From: Steven Fairchild, HP (steve.fairchild@hp.com)
 Date: 3 March 2005
 Subject: SAS 1.1 External Connector Interoperability

Figure 1, Plugfest Configuration

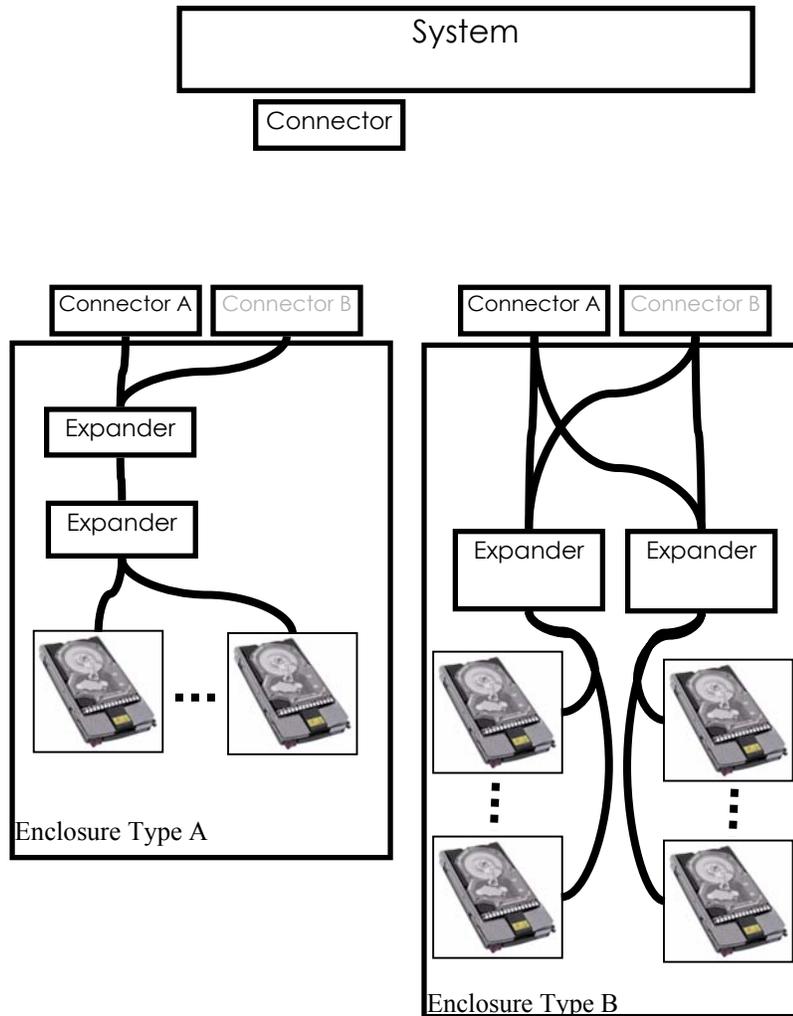
The first issue is an incompatibility that is created when phys routed to an external connector are attached to different expander and/or end devices within the enclosure (see Figure 1).

When the System connector was attached to either of the enclosures (from different manufacturers) the devices were properly discovered. Both enclosures were designed to be “daisy chained” to additional enclosures. When enclosures from the same manufacturer were

“daisy chained” (Enclosure type A to Enclosure type A or Enclosure type B to Enclosure type B) the topology was properly discovered. However when enclosures were “daisy chained” to each other (Enclosure Type A to Enclosure Type B or Enclosure Type B to Enclosure Type A) the topology was not properly discovered.

For “daisy chaining” to function, both enclosures defined one connector (assume Connector A for both enclosures) to use Table routing for the phys in the connector and one connector (assume Connector B for both enclosures) to use Subtractive routing for the phys in the connector. This allows the normal SAS routing behavior of chaining Table to Subtractive to create a large expander device set.

Enclosure Type A chose to attach all of the phys within each of its connectors to a single expander. Enclosure Type B chose to attach the phys within each of its connectors to multiple expanders. These two design choices are what caused the interoperability problem. When Enclosure Type A, Connector B is attached to Enclosure Type B, Connector A (Subtractive phys of Enclosure A to Table phys of Enclosure B) a conflict occurs because the expander attached to Enclosure Type A, Connector B has to different SAS Addresses attached to its Subtractive phys. This is an illegal routing configuration, because the expander attached to Enclosure Type A, Connector B cannot determine where to route its Subtractive addresses. Similar routing issues result from the different connection combinations (see Table 1).

From Table 1, the only legal connection Enclosure A, Connector A attached to Enclosure B, connector B had a problem due to a design decision based on the assumption that a connector would only present a single SAS address if it was attached to an expander.

To resolve this interoperability issue, HP would propose the following text (in blue) be incorporated in SAS 1.1;

Change the definition of an enclosure to match SES;

3.1.57 enclosure: [The box, rack or set of boxes providing the powering, cooling, mechanical protection, EMI protection and external electronic interfaces for one or more SCSI devices.](#)

- a) transmit the same [device type, protocol bits \(e.g. SMP TARGET PORT\)](#) and SAS address (see 4.2) during the identification sequence (see 7.9);

An external expander port shall report the same DEVICE TYPE, protocol bits (e.g. SMP TARGET PORT) and SAS ADDRESS in the IDENTITY address frame (see 7.8.2) for all phys of the port.

An external expander port shall report the same SAS ADDRESS and ROUTING ATTRIBUTE in the SMP DISCOVER (see 10.4.3.5) response for all phys of the port.

An external expander port with a ROUTING ATTRIBUTE set to Table routing attribute shall have the same number of route table entries for all phys of the port.

The pins of an external receptacle connector may be attached to one or more SAS devices (see 4.1.4).

The pins of an external receptacle connector may be attached to only one expander device (see 4.1.5), with the phys attached to the pins representing a single expander port (see 4.6.2).

Figure L. 1, SAS Icon for External Receptacle Connections to End Devices (e.g. HBA's or Enclosures without Expander ports)

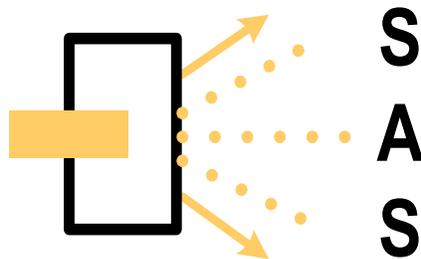
The SAS icons are shown in figures L1 to L3. One or more of these icons should be located near the external receptacle connector for SAS devices, expander devices or enclosures compliant with this standard.

Figure L. 2, SAS Icon for External Receptacle Connections to Expander Ports with Table routing attribute

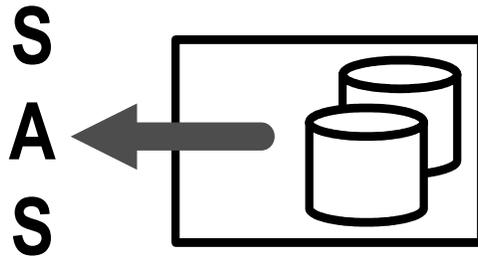
Figure L2 shows the SAS icon for an external receptacle connection for SAS devices attached to expander ports with the table routing attribute. An enclosure using the external receptacle connector to attach to an expander port with table routing attribute should be referred to as the ENCLOSURE OUT PORT.

Editor’s Note: the import of the icon into the word document changed the end point of the arrow from square to round. The preference is for a square endpoint.

Figure L. 3, SAS Icon for External Receptacle Connections to Expander Ports with Subtractive routing attribute

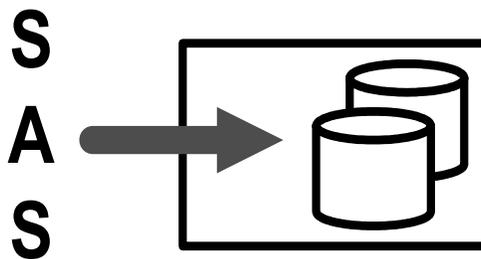
Figure L3 shows the SAS icon for an external receptacle connection for SAS devices attached to expander ports with the subtractive routing attribute. An enclosure using the external receptacle connector to attach to an expander port with subtractive routing attribute should be referred to as the ENCLOSURE IN PORT.

Editor’s Note: the import of the icon into the word document changed the end point of the arrow from square to round. The preference is for a square endpoint.

Figure L. 4, SAS Icon for External Receptacle Connections on cables that may be attached to End Devices or Expander Ports with Table routing attribute

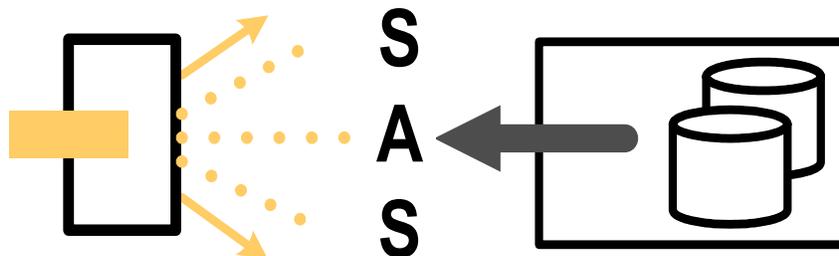
Multiple SAS icons should be located on cables that connected SAS devices. Figures L4 to L6 show the placement of combinations of SAS icons on cable external receptacle connections. To facilitate ease of use, cable ends may be identified with different icons.

Editor's Note: the import of the icon into the word document changed the end point of the arrow from square to round. The preference is for a square endpoint.

Figure L. 5, SAS Icon for External Receptacle Connections on cables that may be attached to End Devices or Expander Ports with Subtractive routing attribute

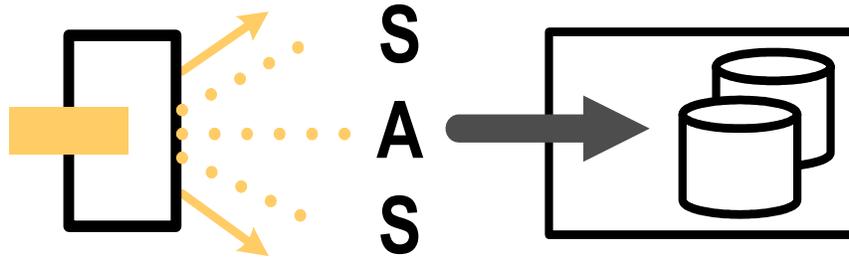
Editor's Note: the import of the icon into the word document changed the end point of the arrow from square to round. The preference is for a square endpoint.

Figure L. 6, SAS Icon for External Receptacle Connections on cables that may be attached to End Devices or Expander Ports with Table or Subtractive routing attribute

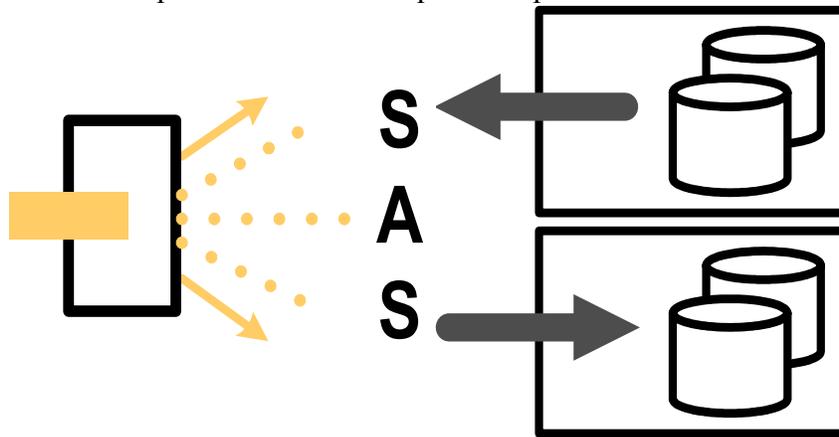
Editor's Note: the import of the icon into the word document changed the end point of the arrow from square to round. The preference is for a square endpoint.

Figure L. 7, Interoperable External Cable using multiple SAS Icons

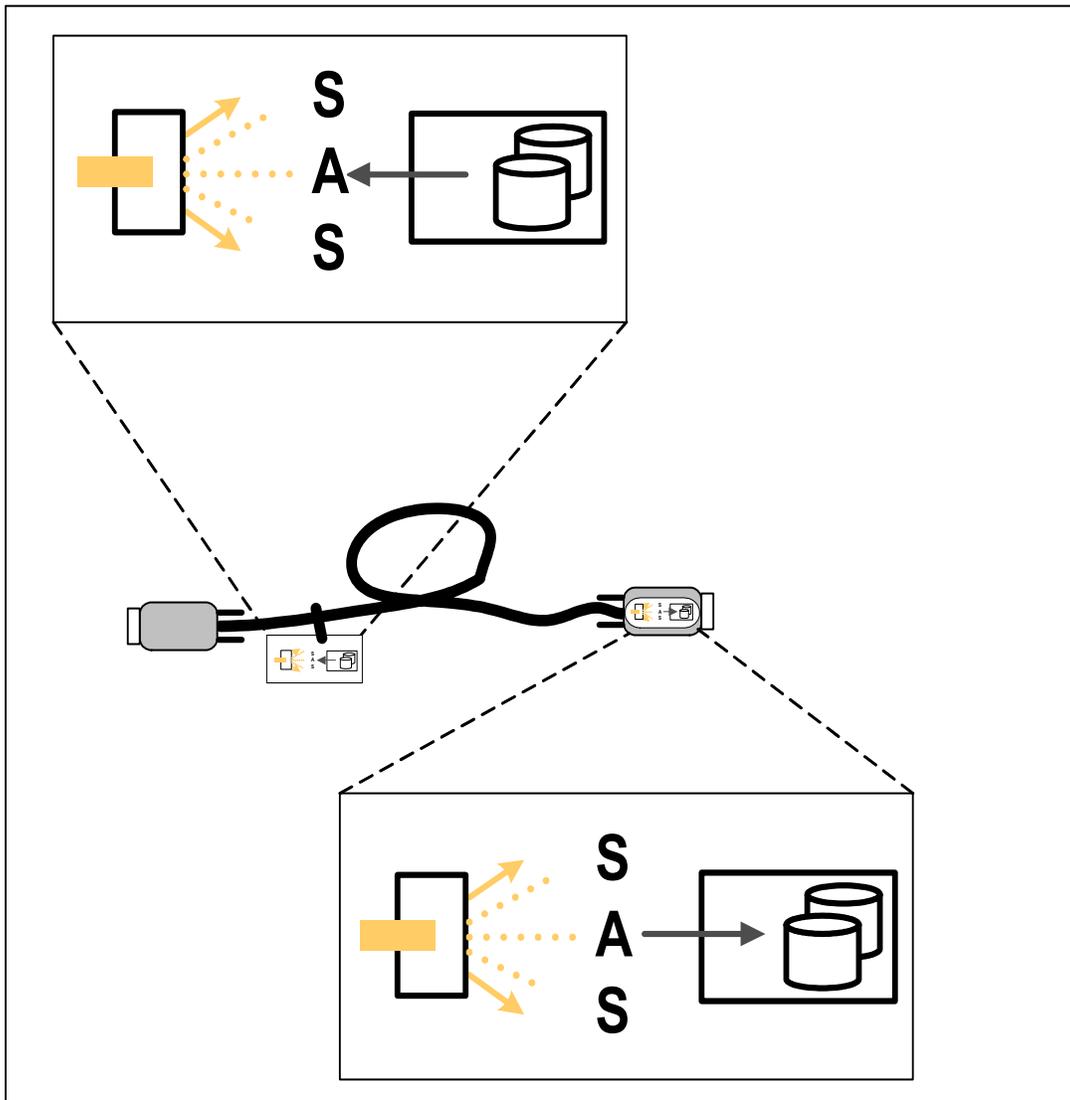
Figure L7 shows a cable that connects an end device or expander port with table routing attribute to another end device or expander port with subtractive routing attribute. Each end of the cable is identified with either a label on the external receptacle connector or with a tag affixed near the external receptacle connector.

Figure L. 8, HBA to Enclosure connection example using icons

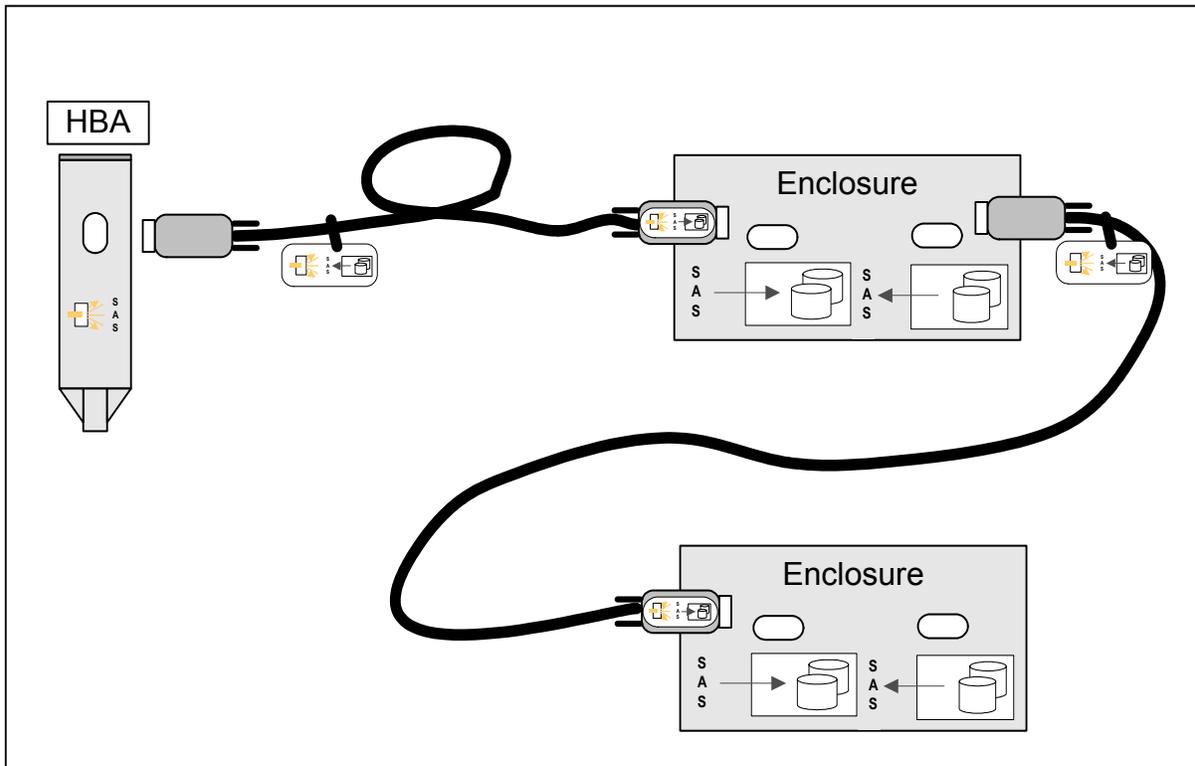
An example of an HBA and Enclosure being connected with the interoperable external cable is shown in figure L8. Figure L8 also demonstrates that the same interoperable external cable may be used to connect enclosures in a cascaded manner.
